Consultation Response from KC, Highways Development Management (HDM)
2024/91242 Land north east of Shepley Road, Stocksmoor, Huddersfield, HD4 6XW
Erection of residential development (up to 50 dwellings) with associated access, parking, public open space, landscaping and infrastructure
Date Responded: 14/10/24 Responding Officer: A.Darwin Responding Ref: 12-33/18

RECOMMENDATION: HDM are unable to support the development proposals as this time in their current form.

Access to the site is proposed via a new priority junction on Shepley Road, as shown on AMA drawing AMA/20547/SK002-P05. This access has been designed taking into consideration some of the concerns raised by HDM at the pre-application stage, and includes the following:

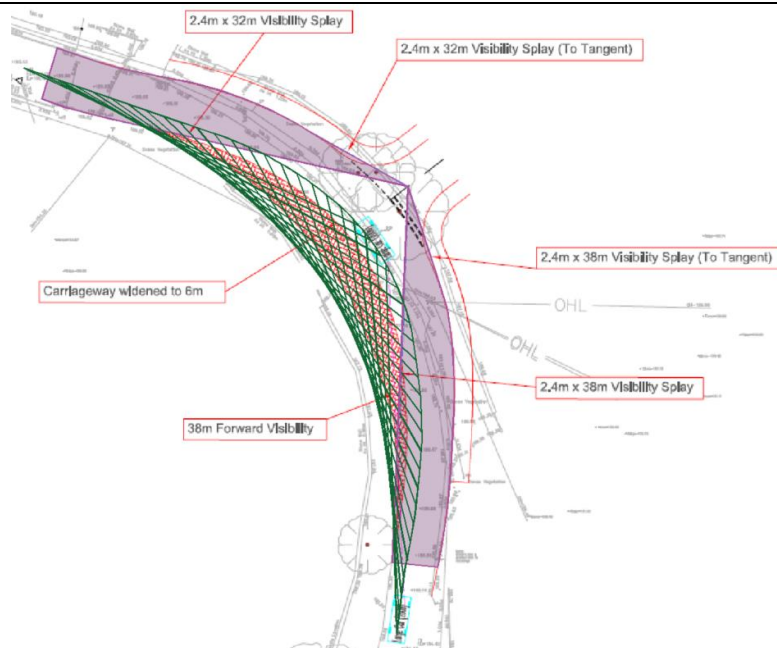
The principle of the site access arrangements are considered appropriate. However, there are a number of issues that need to be addressed before the arrangements can be accepted, which are as follows:

- Additional swept path analysis is required to confirm that a large vehicle (e.g. refuse vehicle) can pass a light vehicle on the widened bend (e.g. passing a stationary car waiting to turn right into the access). This may result in some additional carriageway widening being necessary (in addition to the widening to 6m as currently proposed). It is noted that Shepley Road is signed as being unsuitable for heavy vehicles. As such, passing by large vehicles will be infrequent and only a minimum level of clearance (e.g. 250-500mm) is expected to be demonstrated by this additional swept path analysis.

- The speed data included in the TA confirms that 85th percentile speeds on Shepley Road were recorded as 24.0mph southbound (e.g. exiting the village) and 27.5mph northbound (See section 4.2 of TA), and that the junction visibility splays and forward visibility splays at the bend have been provided in accordance with these speeds. However, following further information provided by the transport consultant who produced the TA, it has been confirmed that the speed survey was undertaken within the immediate vicinity of the site proposed access (e.g. on the apex of the bend) rather than on approach to the proposed junction. Therefore, the approach speeds to the junction may be slightly higher than those recorded by this speed survey. HDM have checked the detailed speed data results that also include approximate vehicle classifications, which suggest that the proportion of larger vehicles (e.g. OGV1, OGV2 and PSV) are at times over 10%. Therefore, the Stopping Sight Distance (SSD) should be based on a deceleration rate of 0.375g, rather than the 0.45g deceleration rate that has currently been used. Based on the higher recorded 85th percentile speed of 27.5m (northbound) and the deceleration rate of

0.375g, this equates to a SSD requirement of 41m. Therefore, in accordance with good practice, it is expected that the 41m SSD requirement is applied to all visibility splays at the junction and forward visibility around the bend, which should be clearly demonstrated on the plans.

- Some long section information has been provided in Appendix C of the TA, showing what appears to be the revised alignment of Shepley Road following the realignment works. This long section has then been used to seek to demonstrate that the visibility splay requirements are achieved vertically. However, the long section information is very limited in detail and does not include gradient or vertical alignment information to enable HDM to assess the feasibility of the proposals. It is noted that the gradient of Shepley Road (as amended by the revised alignment) within the vicinity of the site access should not exceed 1:12 within the full limits of the junction bellmouth and its immediate approaches, otherwise suitable crossfalls gradients on the site access minor arm are unlikely to be achievable (these should not exceed max. 4% as per the Highway Design Guide SPD). Based on HDMs check of the limited information provided on the long section, it appears that the site access may need to be relocated further to the west where the carriageway gradient would be reduced. Further level information is required, included detailed long section information on Shepley Road that clearly shows the proposed carriageway gradients, including tie-ins to the wider carriageway vertical alignment, together with more detailed vertical alignment/levels information within the minor arm of the junction to ensure that suitable crossfall gradients can be achieved.

- The proposed carriageway alignment on the southeast side of the bend appears to show the edge of the proposed carriageway immediately adjacent to the highway boundary. This should be amended to ensure that min. 600mm clearance is maintained.

- Block paving has been proposed in the inside of the realigned bend to protect the forward visibility splay envelope. The provision of a hard paved surface is welcomed, which should ensure that adequate visibility is maintained. However, a tarmac surface is likely to be preferred, to reduce the costs of future maintenance. The final detail of the paving type could be agreed at the S278 detailed design stage. However, the current paving proposals taper down to nothing at either end, which is not appropriate, and should be amended to provide to a minimum width of 600mm and include edging kerbs.

- It is expected that improved signage and road markings are provided at the 30mph/NSL transition to the south of the site access, which should include a replacement 30mph roundel and improved terminal signage on yellow backing boards. These should be shown on the proposal plans.

- Dropped pedestrian crossings with tactile paving should be provided at the site access, which should be shown on the plans. It should also be confirmed that adequate gradients are achieved at the crossing points.

HDM have rechecked the junction visibility splays and the required forward visibility around the bend based on the 41m SSD requirement, as shown on the sketch below (note this will change once the required adjustments to be carriageway alignment have been made). This indicated that adequate visibility could be achievable horizontally, but this needs to be confirmed by the applicant on revised plans and also checked vertically. It is noted that the forward visibility requirement (measured 1.5m from carriageway edge) should extend to the south by a minimum of 41m from the rear of a waiting righting vehicle into the access (as shown in green on the sketch) and 41m to the northwest of the drivers eye position of a waiting right turner.

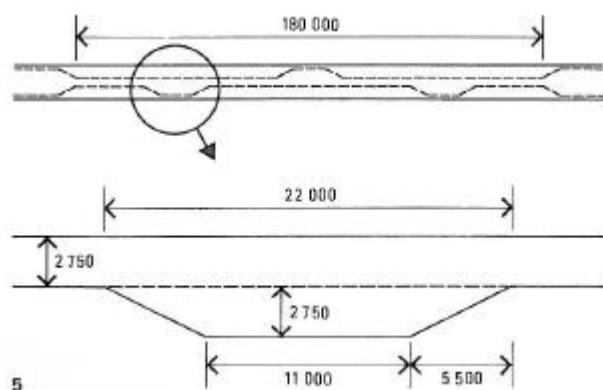
The applicant has not proposed any improvements to Stone Wood Lane as part of the proposals to address the existing deficiencies, and has sought to down play the problems by suggesting that development users are unlikely to use this route to access facilities in Shepley, and would instead travel the longer route to Shepley via Thunderbridge. HDM do not accept this (see further comments below regarding the traffic assessment) and consider the intensification of use of this route would adversely affect it's operation, both for drivers, but more importantly for pedestrians and cyclists (on this NCN route), who would be at increased risk of collisions with passing and reversing vehicles.

It is noted that HDM have undertaken multiple site visits along Stone Wood Lane, and on a number of occasions have encountered a vehicle approaching in the opposite direction. This has resulted in one of the drivers having to yield and then reverse back for a substantial distance to reach a point where vehicles can pass, at the sub-standard passing places that are available. This problem is then compounded when other vehicles arrive during these occurrences. Depending on the locations where vehicles meet, this can require multiple vehicles to reverse

back beyond the first informal passing point they reach, as there is insufficient space for the other vehicle to pass multiple vehicles.

As such, HDM remain of the view that improvements to Stone Wood Lane should be provided by the development, to address some of these existing deficiencies, and safely accommodate additional development traffic (by all modes) along this route.
